## IN THE UNITED STATES PATENT AND TRADEMARK OFFICE

Applicant: Dardo Bonaparte Lujan  
Serial Number: 10/791,054  
Filing Date: March 2, 2004  
Title: Armored Assembly  
Examiner: Troy Chambers  
Art Unit: 3641

**RESPONSE TO OFFICE ACTION**

FIG. 16

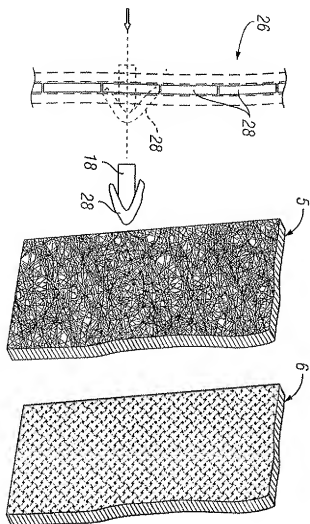
In the Office Action, the Examiner has again objected to the drawings under 37 CFR §1.83(a) in that the drawings are deemed not to show every feature of the invention. Specifically, the Examiner contends that the “at least one projectile stopping panel” (Claims 15, 16), “the impact cushioning panel” (Claim 28), and “the projectile stopping panel comprising loosely-entangled fibers” (Claim 29) are not shown in the drawings. In the previous Office Action, Applicant pointed out to Examiner that these features were already shown in FIGS. 1 and 9. During an informal telephone conversation with Examiner on August 8, 2006, Examiner noted that these features are not shown in FIGS. 15 and 16, which represent specie E elected with traverse by Applicant pursuant to a restriction requirement. Examiner also stated that he would not look outside FIGS. 15 and 16 for the above referenced features.

The attached sheet of drawings includes changes to Fig. 16. This sheet, which includes Fig. 15-16, replaces the original sheet including Fig. 15-16. In Fig. 16, elements 5 and 6 from Fig. 1 have been added to Fig. 16.

Pursuant to Examiner’s suggestion that he will not look at any other figures other than FIGS. 15 and 16 for the features of the invention, replacement drawing sheets are attached to this response clearly depicting the “at least one projectile stopping panel” (Claims 15, 16), “the impact cushioning panel” (Claim 28), and “the projectile stopping panel comprising loosely-entangled fibers (Claim 29) in FIG. 16. Specifically, the “at least one projectile stopping panel” and “the projectile stopping panel comprising loosely entangled fibers” are identified by reference numeral 5. The “impact cushioning panel” is identified by reference numeral 6.

Paragraph 0042 of the published application refers in the description of FIG. 1 to “at least one projectile-trapping panel 5.” Likewise, the specification at paragraph 0070 refers to “at least one projectile-stopping panel, or trapping panel”, which indicates that the terms “projectile trapping panel” and “projectile stopping panel” are used interchangeably. Such panel is now clearly depicted in FIG. 16 and identified by the reference numeral 5.

The “projectile stopping panel comprising loosely entangled fibers” in claim 29 is also shown in FIG. 16. Applicant respectfully refers Examiner to the preceding paragraph indicating that the terms “projectile stopping panel” and “projectile trapping panel” are used interchangeably. To the extent Examiner believes that the “loosely entangled fibers” portion of claim 29 is not shown, Applicant refers Examiner to paragraph 0055 of the specification, wherein it is disclosed that “the projectile-trapping panels 5 ... may comprise a mass of loosely-entangled microfibers 15, FIGS. 1 and 2.” The same paragraph goes on to state that “the term ‘microfiber’ must be understood as encircling all kind of fibers, filaments, threads and the like.” The term “loosely entangled” is defined in paragraph 0057 of the specification. The term “loosely entangled” is also described and claimed in U.S. Patent No. 6,684,468, col. 4, l. 45 through col. 5, l. 12 and claim 1. Therefore, “the projectile stopping panel comprising loosely entangled fibers” in claim 29 is now depicted in FIG. 16 and identified by reference numeral 5.

Applicant also respectfully submits that the “impact cushioning panel” referred to in claim 28 is now shown in FIG. 16. In paragraph 0043 the specification discloses “at least one impact cushioning panel 6, see FIG. 1”. Again, Applicant respectfully refers Examiner to the description of FIG. 16, paragraph 0069, which also refers to FIG. 1 and incorporates the ballistic panels of FIG. 1 by reference into the description of FIG. 16. Because the “impact cushioning panel”, “the projectile stopping panel”, and “the projectile stopping panel comprising loosely entangled fibers” originally shown in FIG. 1 are now shown in FIG. 16 and identified by the reference numerals 5 and 6, Applicant requests that Examiner withdraws his objection under 37 C.F.R. 1.83(a) that these features are not shown in the drawings.
